**Pacific Gas and
Electric Company**

April 22, 2015

Re: Pacific Gas and Electric Company's Response to CPUC Independent Peer Review Panel Report Nos. 7, 8, and 9

Figure 1. Tornado Plot summarizing seismic hazard parameters and the impact of parameter uncertainty on the total hazard uncertainty. Parameters whose uncertainties contribute more to total hazard uncertainty are shown at the top of the plot.

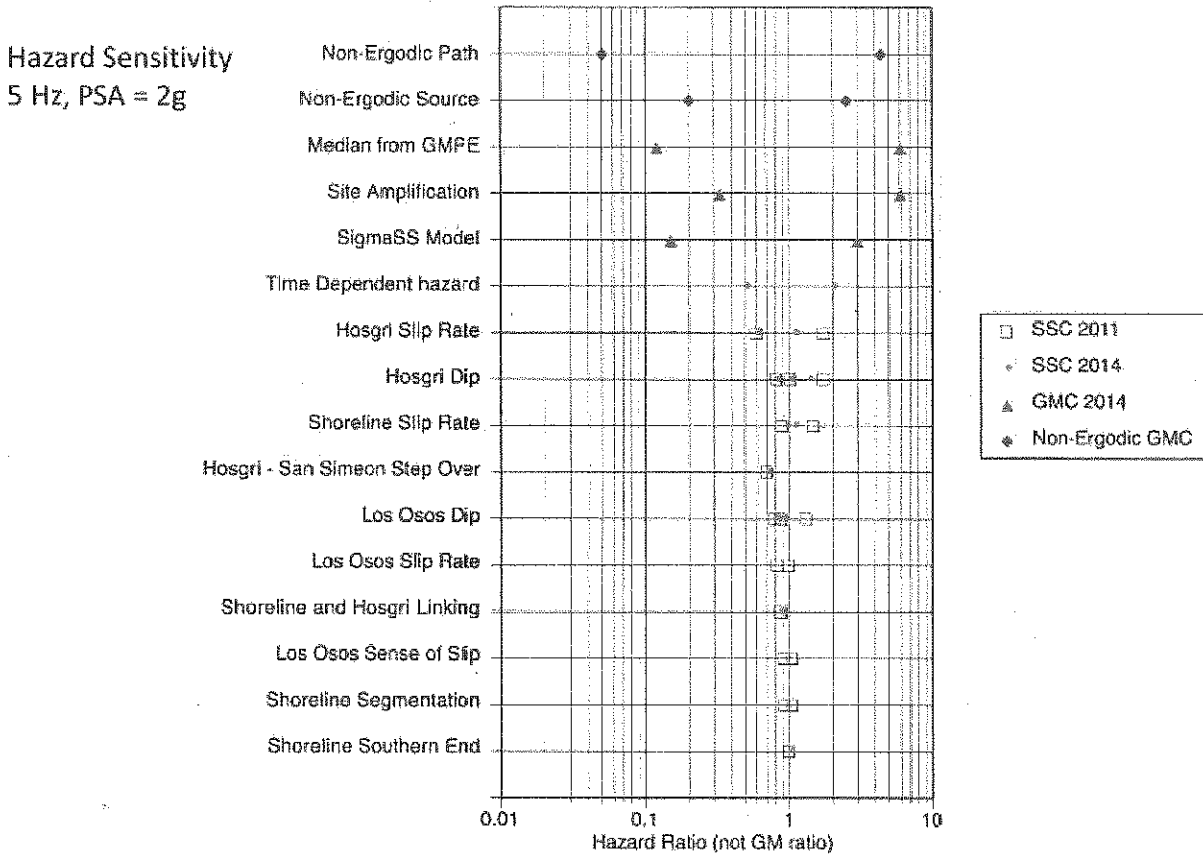
IPRP Report No. 7 suggested areas for additional research, particularly to develop better constraints on age estimates of offset features mapped by the LESS, with an emphasis on the offsets of younger (<20 ka) rather than older offset features. Collecting data to improve the age dates and/or identify additional, younger offset features in the offshore region is a major task. As shown by the tornado plot on Figure 1 below (which is equivalent to Figure 4 of IPRP Report No. 9), the current uncertainties in the Hosgri and Shoreline slip rates, which incorporate large age uncertainties, lead to less uncertainty in the total seismic hazard than the current uncertainties in the rock ground motion models and site amplification models. Therefore, the collection of data to improve the age dates and/or resolution of offset features along the Hosgri or Shoreline fault will likely be a lower priority. The final prioritization of any additional studies to reduce the uncertainty in the hazard will be developed as part of PG&E's ongoing Long Term Seismic Program (LTSP).

The currently available broadband data from small earthquakes does not provide improved constraints on the DCPD site terms because the station coverage is too sparse. Improved source, path, and site response terms are part of a separate longer term study being planned with the Southern California Earthquake Center. This project plan will be developed as part of the overall effort to reduce the uncertainty in the seismic hazard as presented in Figure 1.
